AGENDA PORTLAND PLANNING BOARD MEETING

To: Chair Dundon and Members of the Portland Planning Board
From: Christine Grimando, Senior Planner
Date: April 13, 2018
Project #: PEZ.2017-062
CBLs: 031 J031, 031 J030
Re: Fisherman's Wharf: Application for a Conditional Rezoning Application at 184 Commercial Street
Meeting Date: April 17, 2018

184 Commercial Street Zone Change - Initial Traffic Comments

Figure 5, Site Play Layout B, Setback Reduction Area Circled

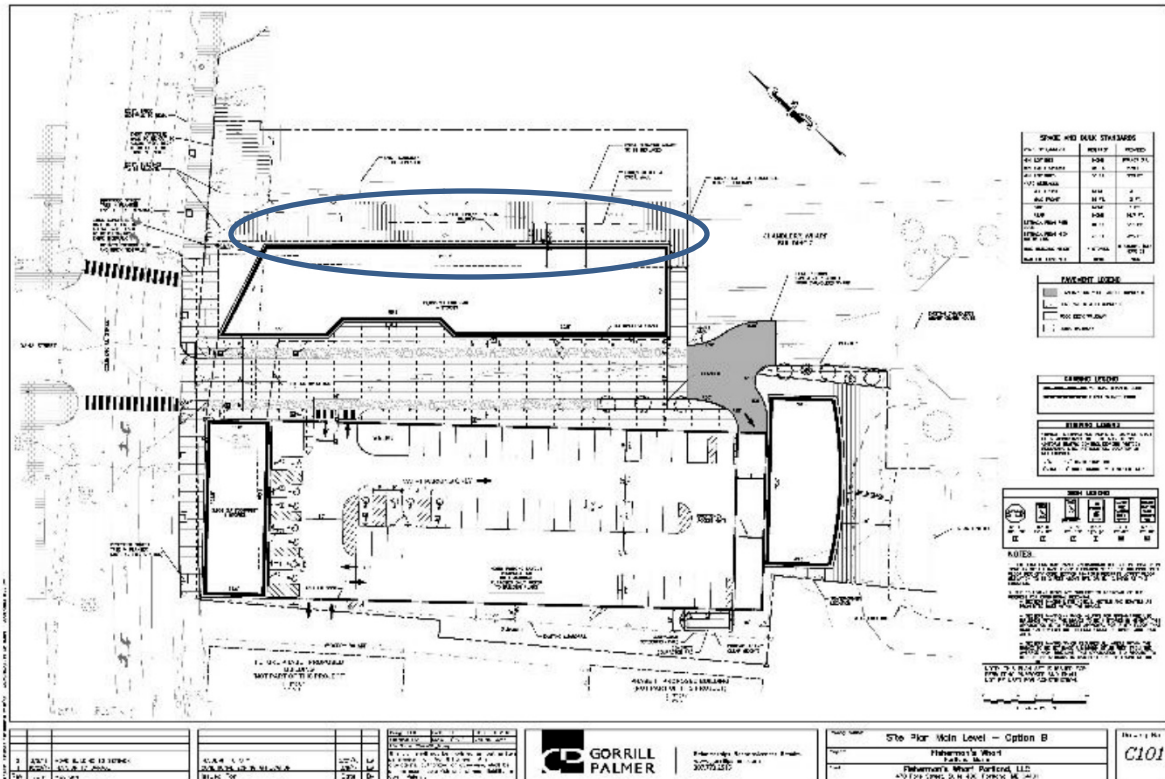
capacity of the area in question to serve water-dependent and/or marine-related uses on the site in the future. The conditional rezoning request retains marine uses in the form of the proposed dispatch center, and maintenance and improvements to the wharf. Marine loading areas and parking are included were included in the initial garage proposal, and current status of proposed users of the parking and loading areas should be updated by the applicant. Physical access to the waterfront is improved through expansion of publicly accessible walkway on the eastern edge of the site, in the current location of Portland Lobster Company and to the east of the proposed hotel/dispatch center.

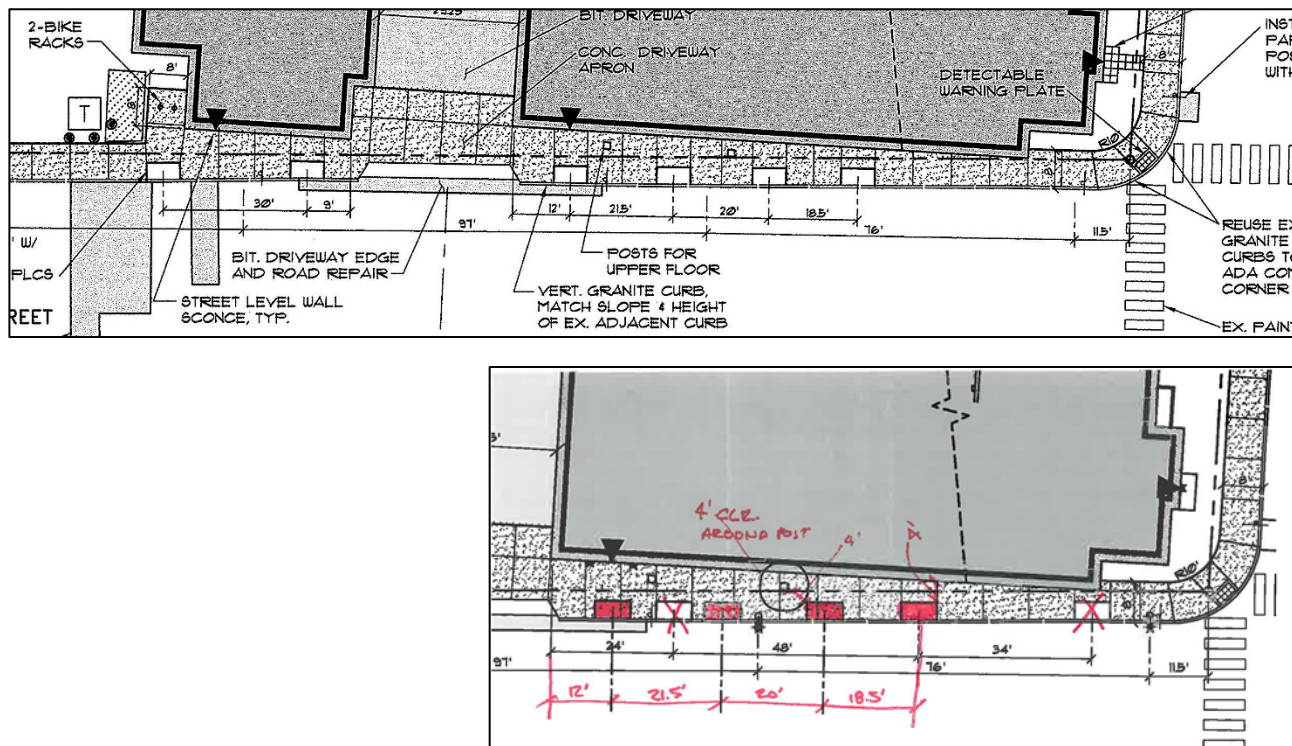
Dear Barbara:

On behalf of Fisherman's Wharf Portland, LLC, Gorrill Palmer is pleased to submit documents for a conditional rezone request to allow the following, as part of the proposed Fisherman's Wharf Redevelopment:

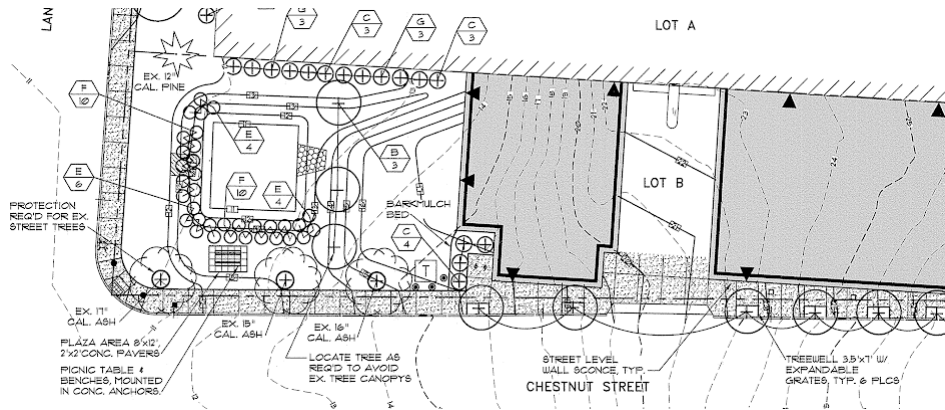
- Who will maintain access drive? **Fisherman's Wharf, LLC**
- Clarify the Casco Bay Dispatch Center. **The Dispatch Center will provide waiting and restrooms for users of water taxi, tur boats, trolleys, etc. The restrooms will not be public.**

- What brand of hotel? **It will be a boutique hotel that will be managed by the applicant.**
- Brick along entire hotel façade would be nice. **The design is in the preliminary stages and the final material is not determined.**
